Airworthiness Directive

AD No.: 2015-0226R3

Issued: 01 June 2016

ATA 25 – Equipment / Furnishings – Hoist – Test / Replacement

Figure 1

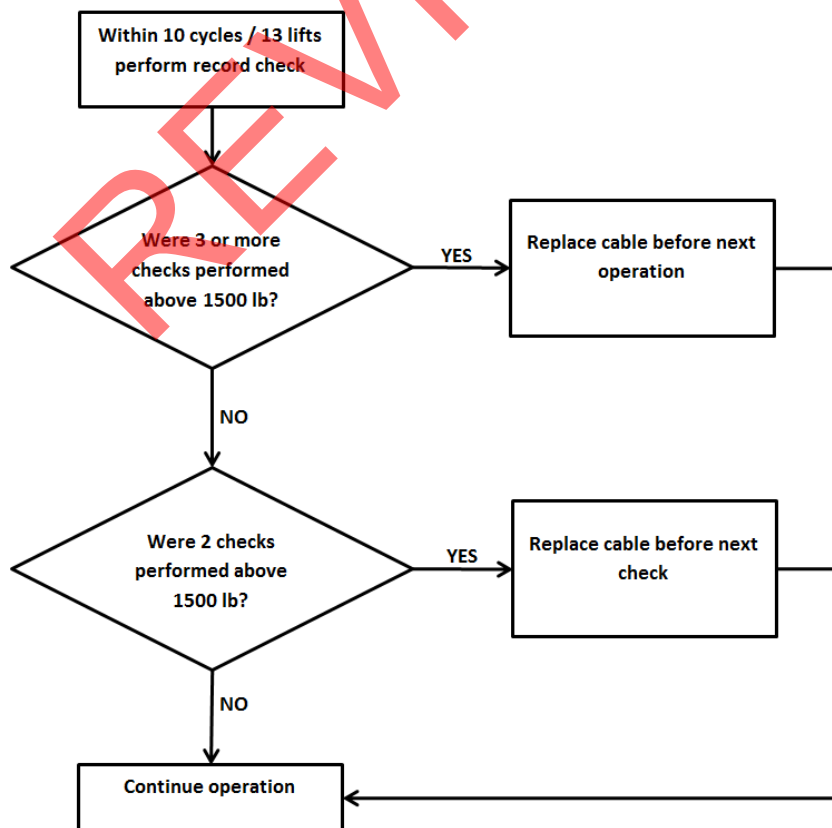
- (1) Within 10 hoist operating cycles or 13 hoist lifts (as applicable, see Note 1 of this AD) after 21 November 2015 [the effective date of the original issue of this AD], determine the P/N of the hoist installed on the helicopter and, if a Goodrich hoist is installed with a P/N listed in Table 1 of this AD, accomplish a records check to determine whether, during any previous hoist load check/test, a cable was load-tested (average of 5 pulls) at 1 500 lb [680 kg] or more. If any cable is identified to have exceeded this limit during three or more hoist load checks/tests, before next hoist operation, replace the affected cable with a serviceable cable. If any cable is identified to have exceeded this limit during two hoist load checks/tests, before the next hoist load check/test, replace the affected cable with a serviceable cable. For replacement of a cable, see figure 1 (flowchart) of this AD.
